Project: Metro Transit Phase 3A- Maintenance and Driver Facility

Contract No.: 8981
Enactment No.: RES-21-00422
Dollar Amount: 9,412,947.00

04/08/21 BID SET
 05/13/21 ADDENDUM #2

SHEET NO:
S-151D

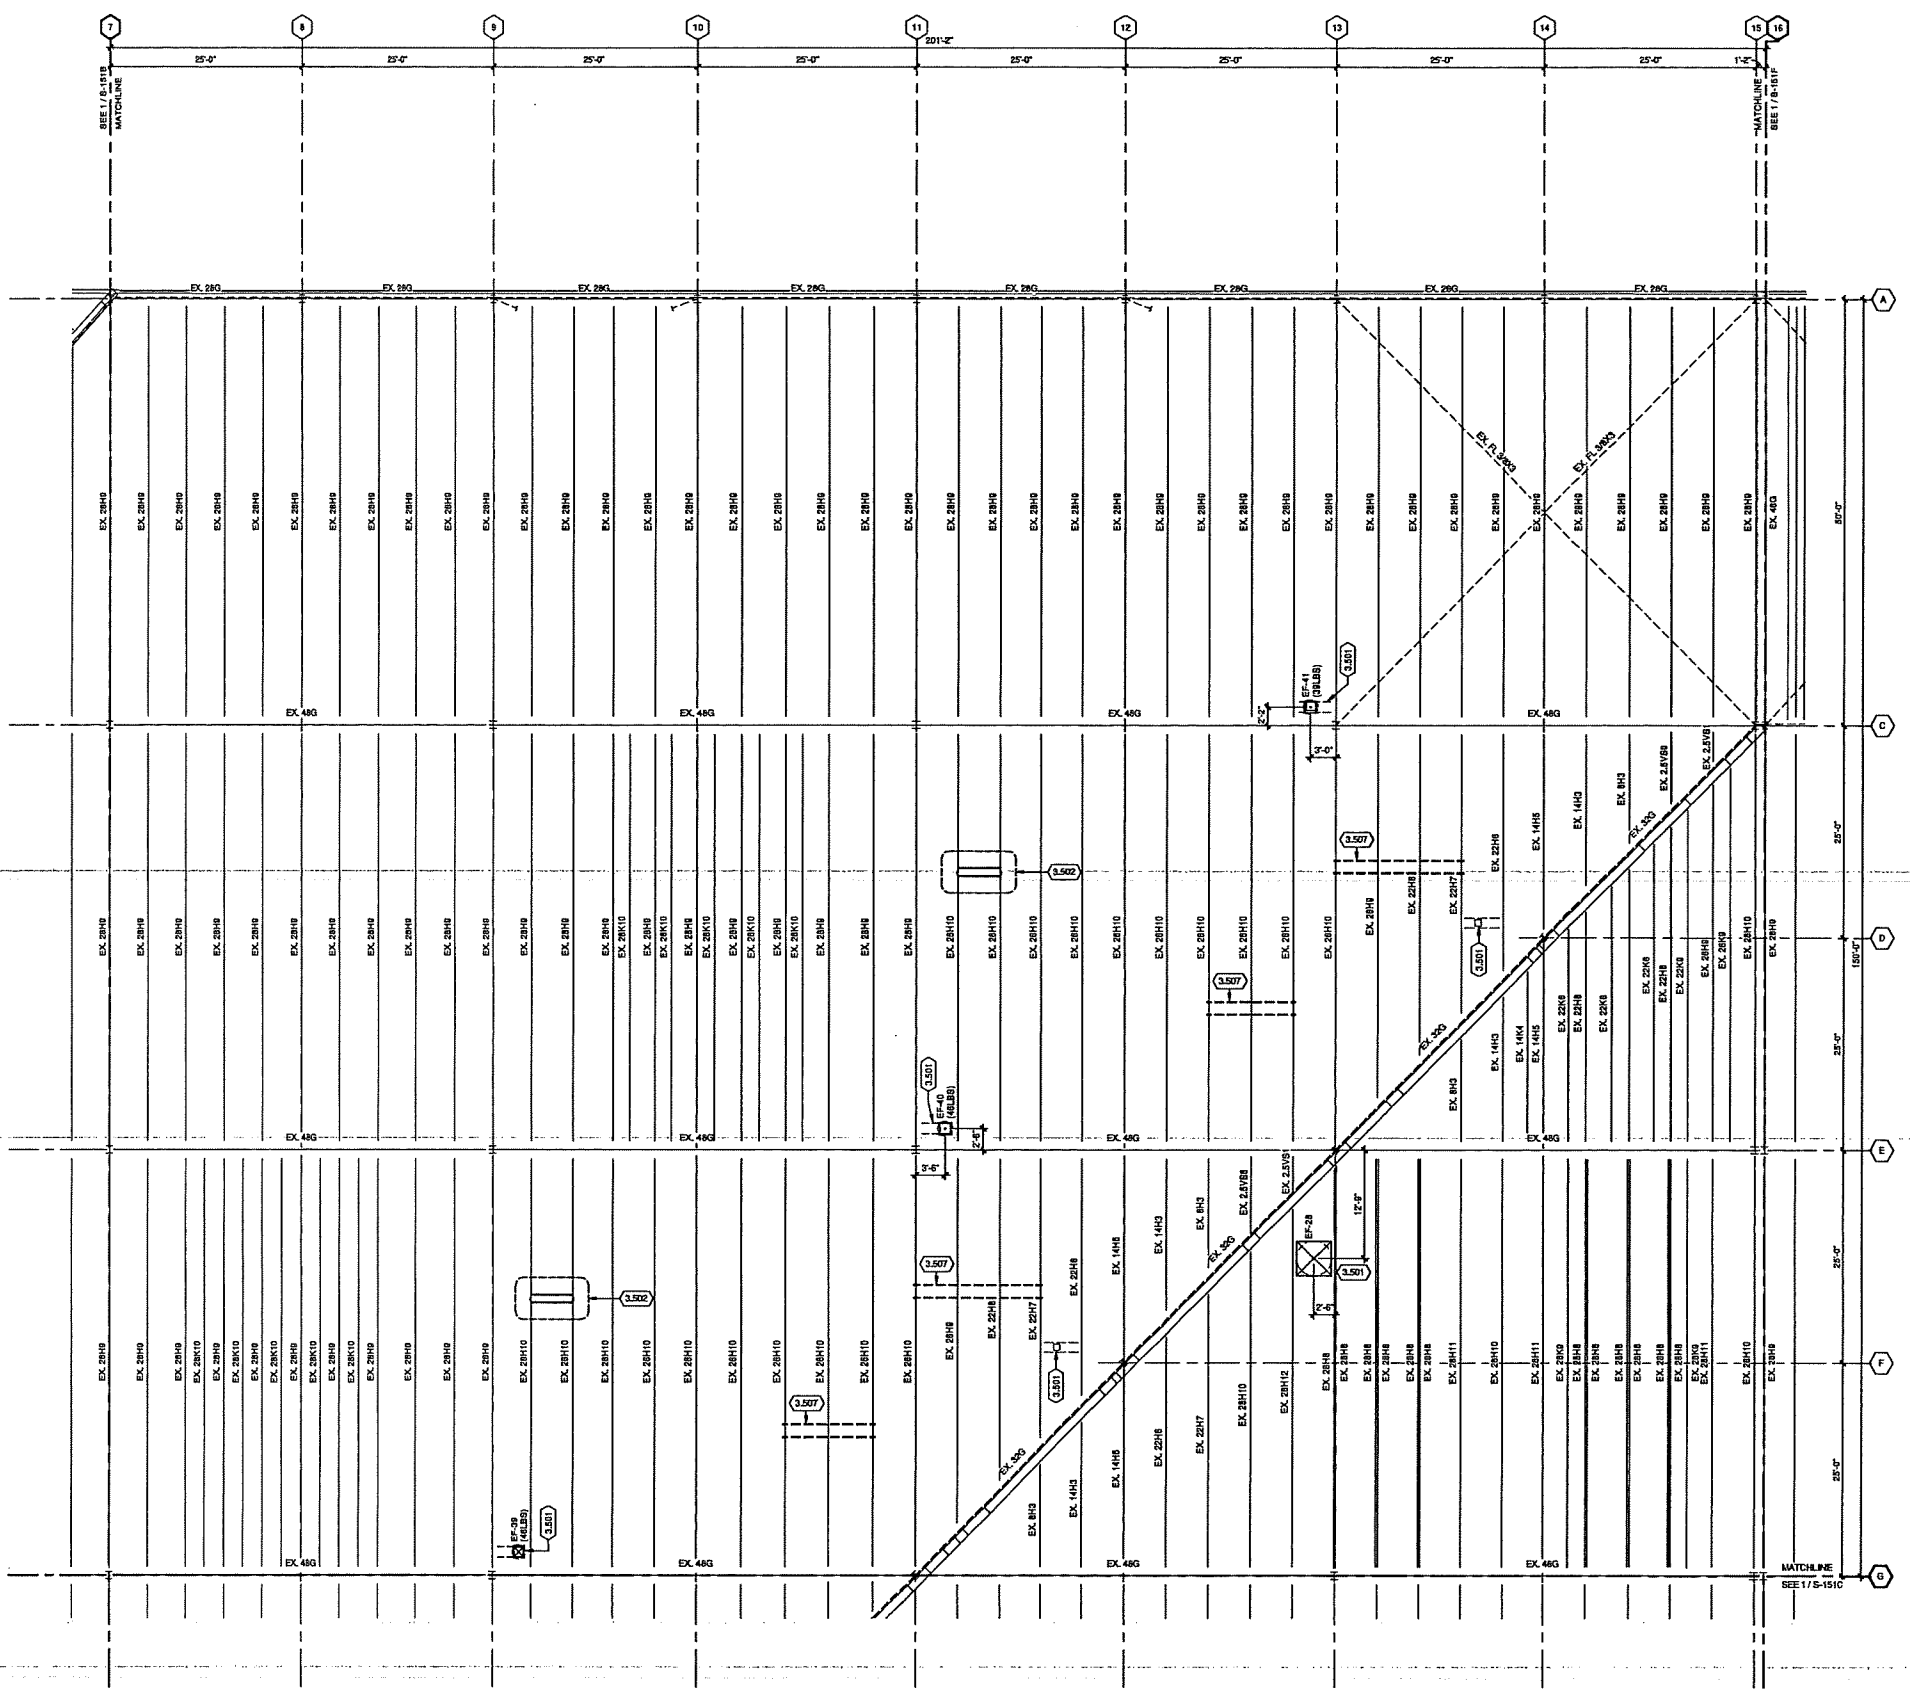
- i. S-151C & S-151D show Structural Framing with keynote 3.507 and details are on 12 & 16/S-541.
- O. Sheet A-101A at intersection of axis G and 1, it references detail 1/A-501 (shown below). It does not list a material for the space noted in Red. Also shown similarly at other wall sections. Please confirm this is empty space.

S-111A

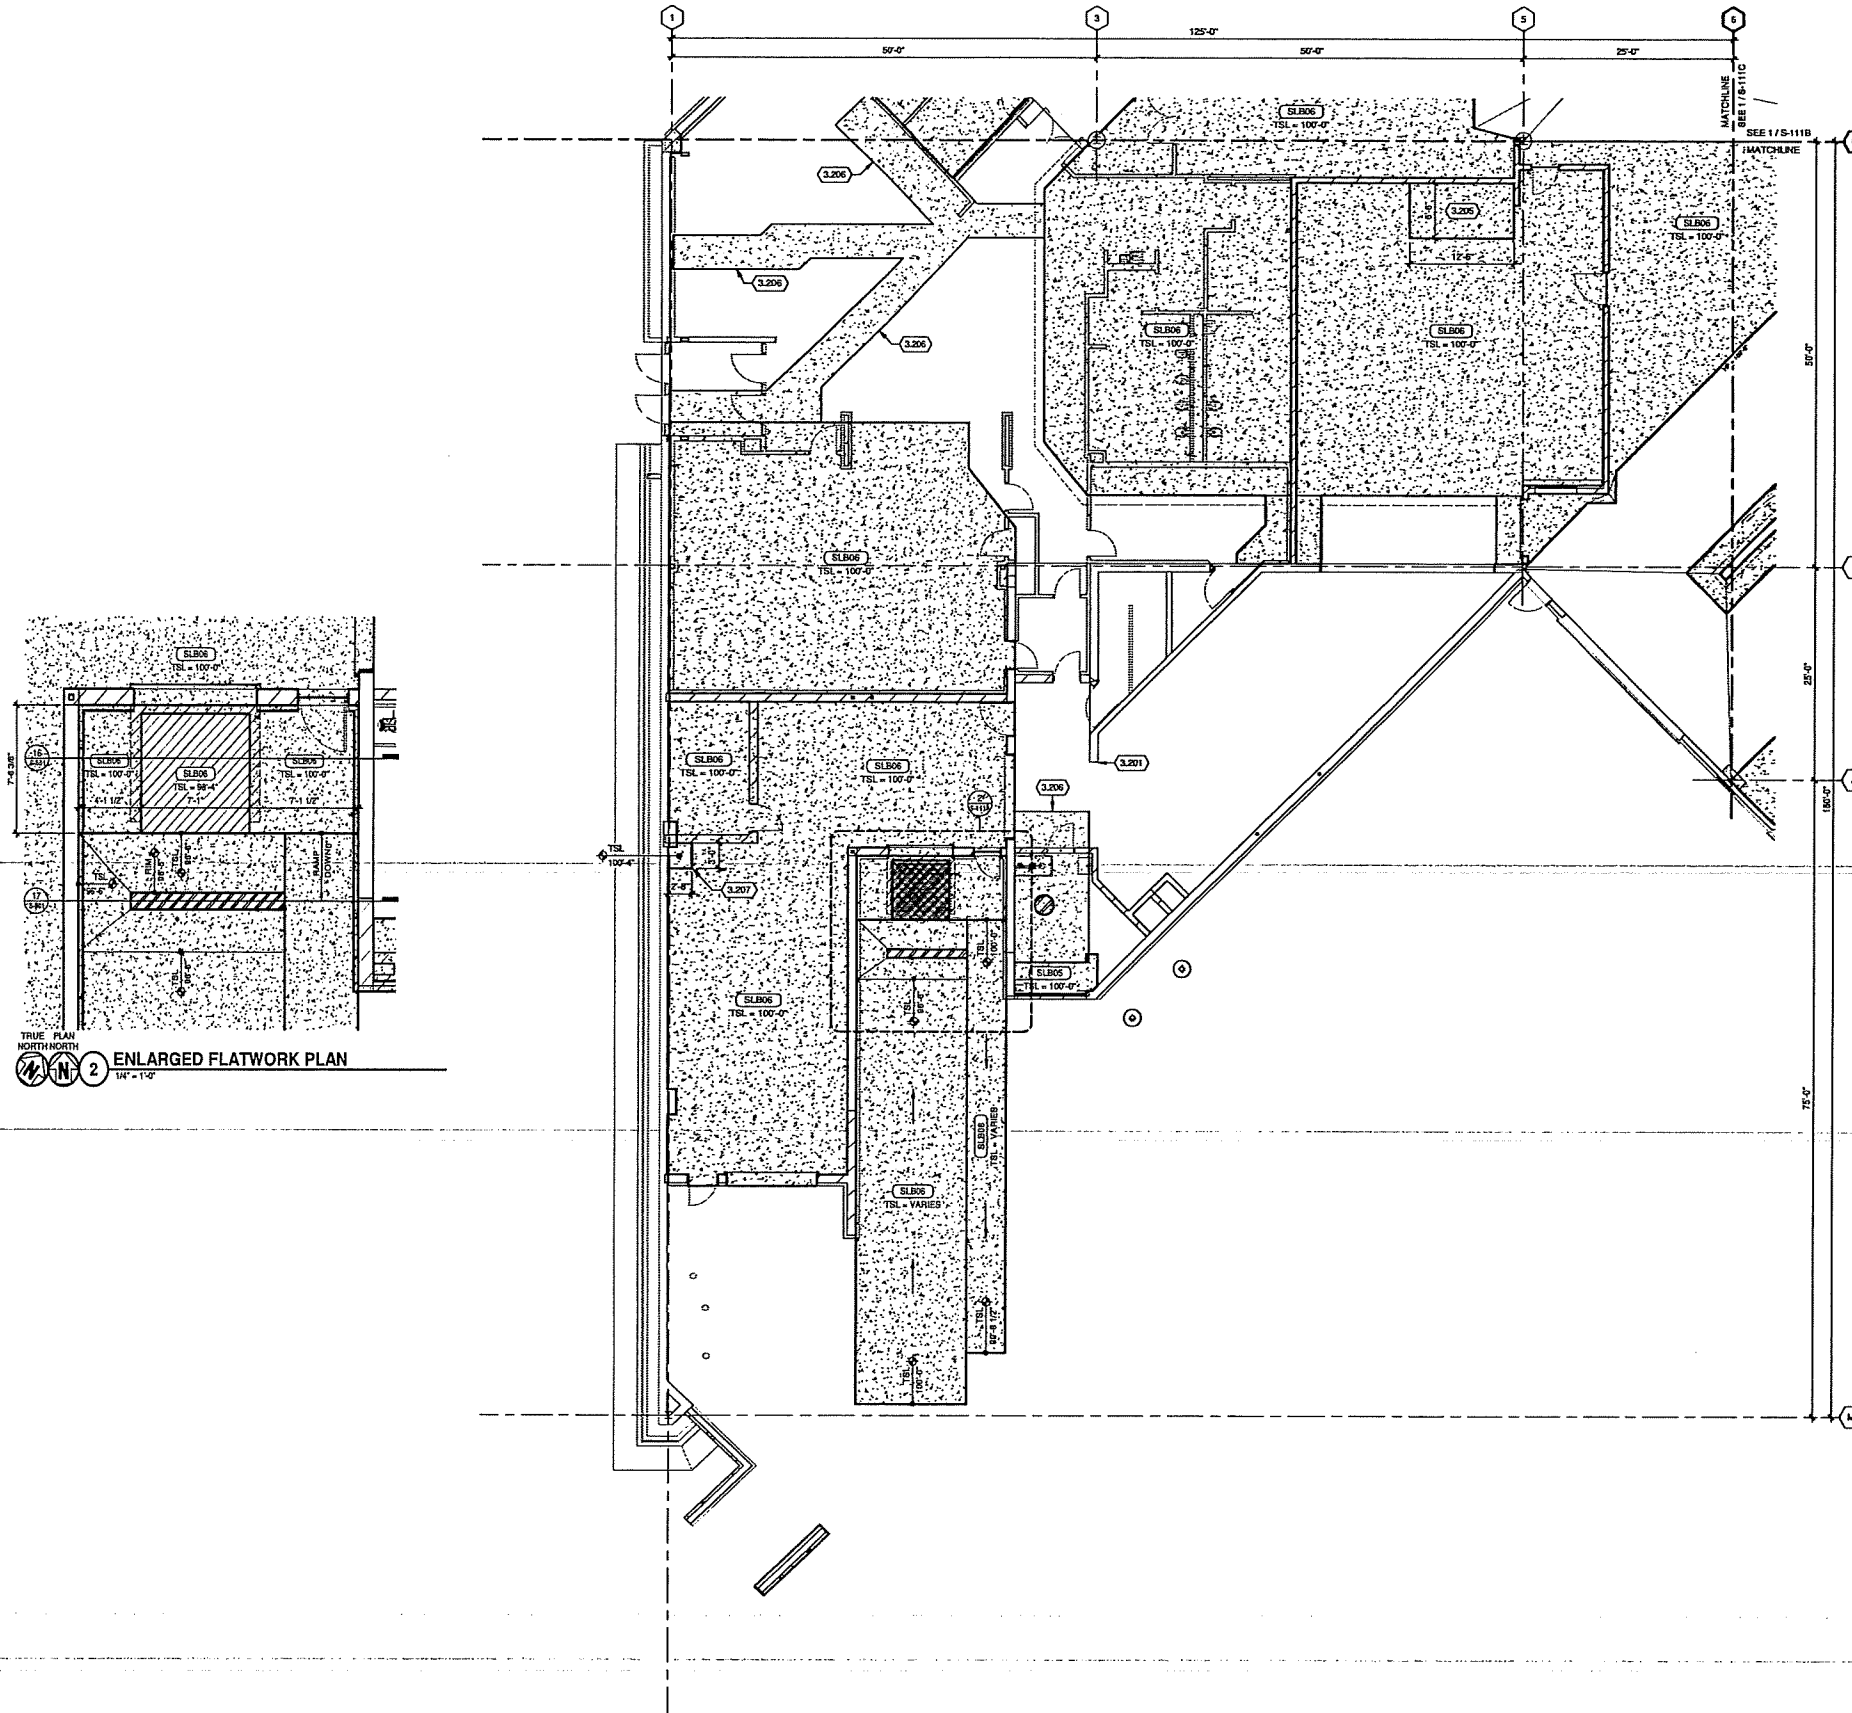
- vi. Drawing S-101C (attached); Added dimensions for pit foundations.
- vii. Drawing S-101D (attached); Added dimensions for pit foundations.
- viii. Drawing S-111A (attached); Paving added at end of truck dock.
